Subject: Amended Workplan for Additional Site Characterization  
Oakland Auto Works (Former Vogue Tyres) – 240 W. MacArthur Blvd., Oakland, CA  
ACEH Fuel Leak Case No. R00000142

Stellar Environmental Solutions, Inc. (SES) is submitting this workplan amendment to you in response to your letter of December 3, 2003 regarding your review of our August 20, 2003 workplan for the referenced site. This workplan amendment addresses all of the technical revisions requested in the Alameda County Environmental Health Care Services Agency (ACEH) requests for modification and/or clarification to the workplan. We trust that based on this response SES can move forward without delay to complete the characterization work. Unless specified otherwise, all other proposed elements of our original workplan are unchanged, and are incorporated by reference. Specific responses to the ACEH letter are presented below.

**Figure 2**

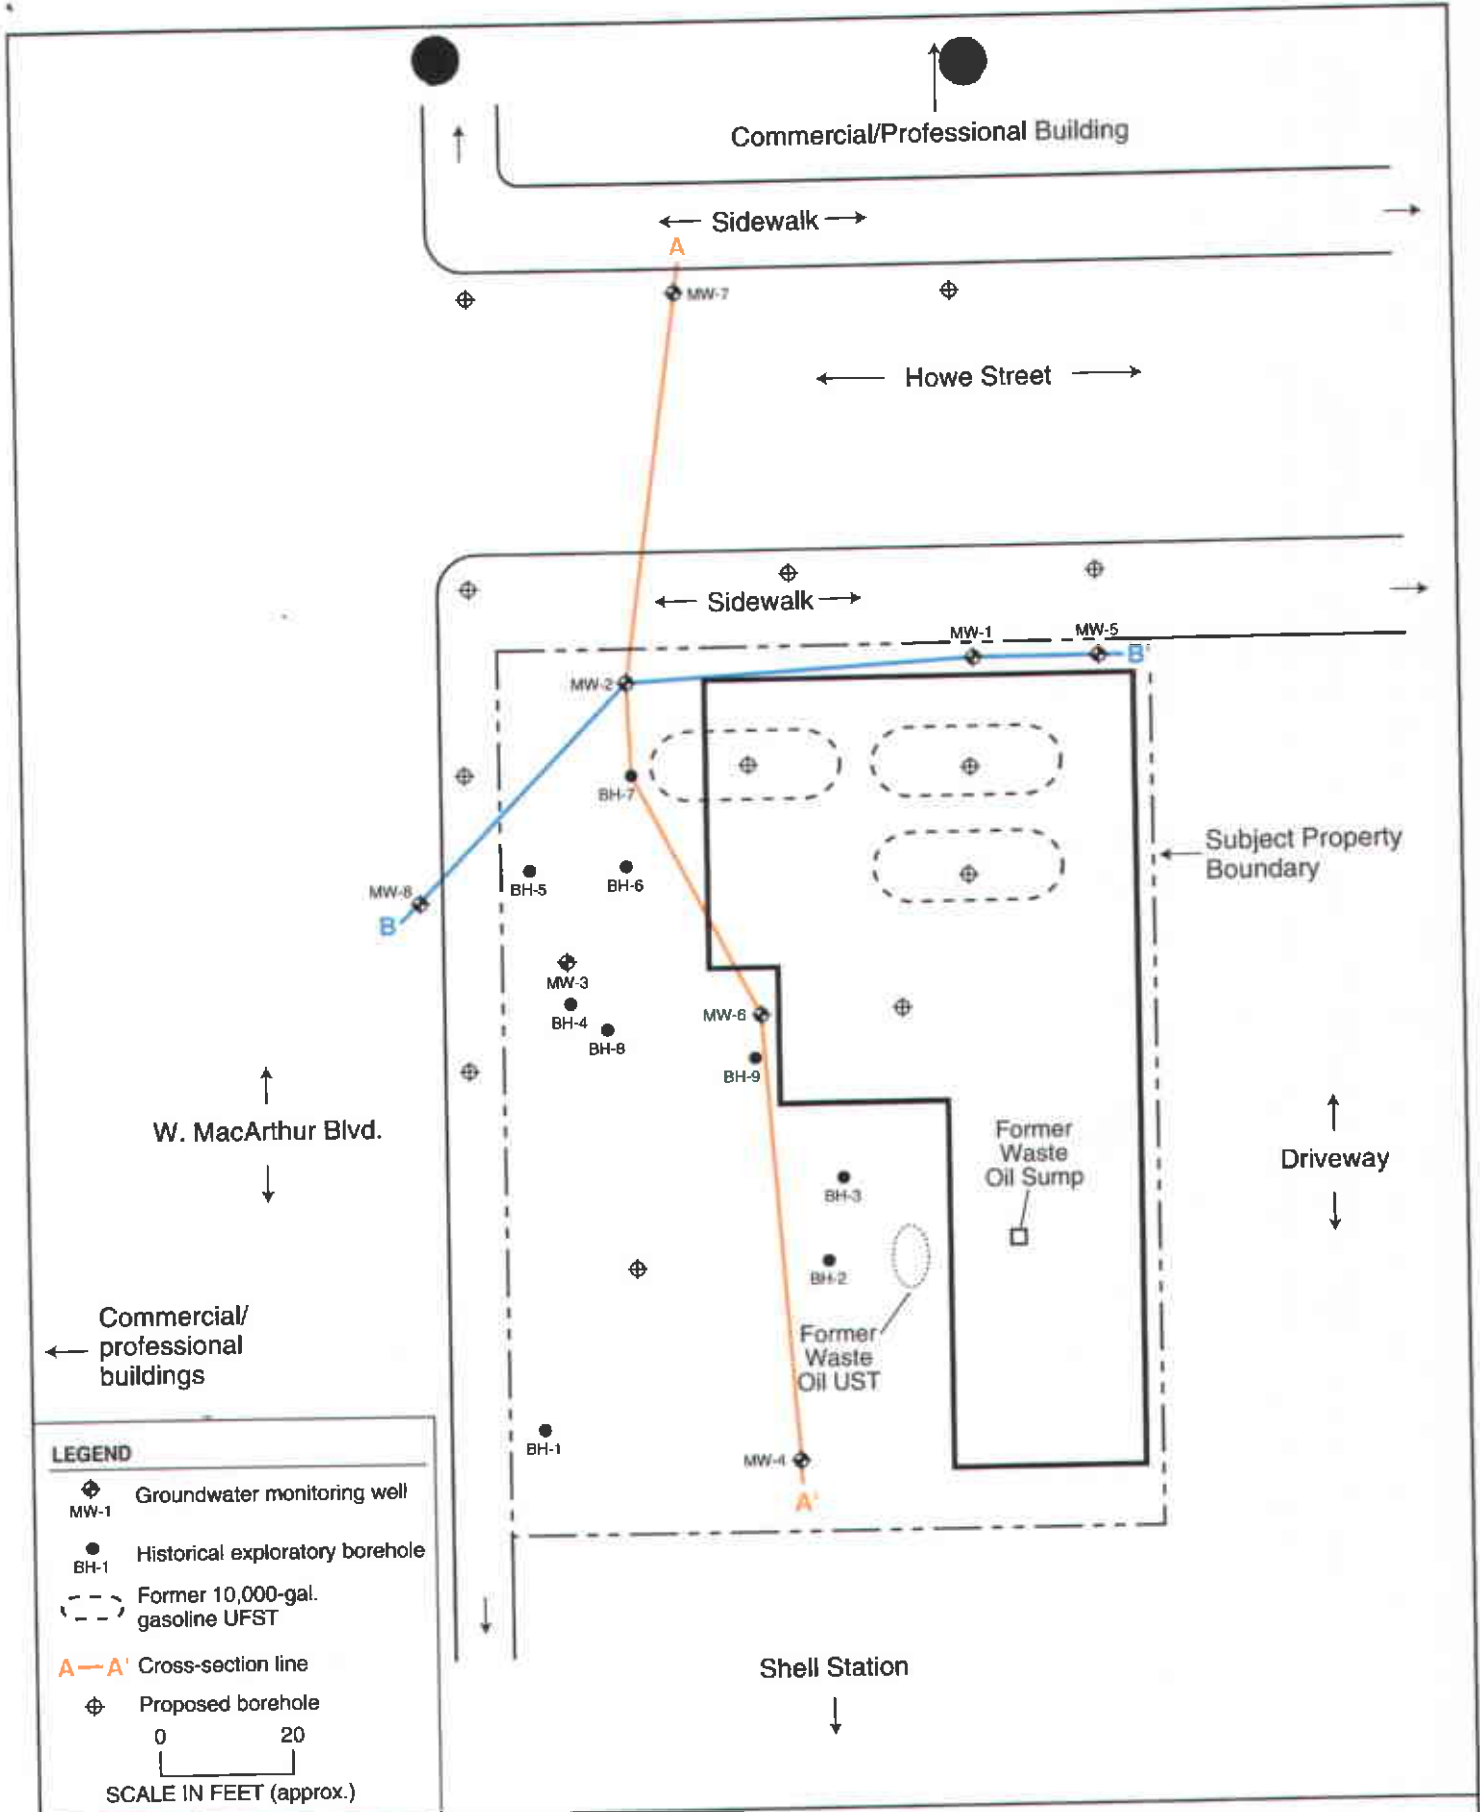
The ACEH requested that the three originally-proposed boreholes to the east of the property be eliminated, and that additional boreholes be placed to the west and to the north of the former UFSTs. Our revised, proposed borehole locations are shown on the attached figure. We are proposing a total of 12 boreholes, focused on the north and west sides of the plume, and in the area of the former UFSTs.

Per ACEH request, attached is the amended site plan showing the site cross-section locations. The cross-sections for the Soil and Water Investigation Report will be amended to include the findings of the proposed investigation, including soil and groundwater analytical results and utility conduits. The cross-sections will be used in the Report to evaluate the probability of the plume encountering preferential pathways.
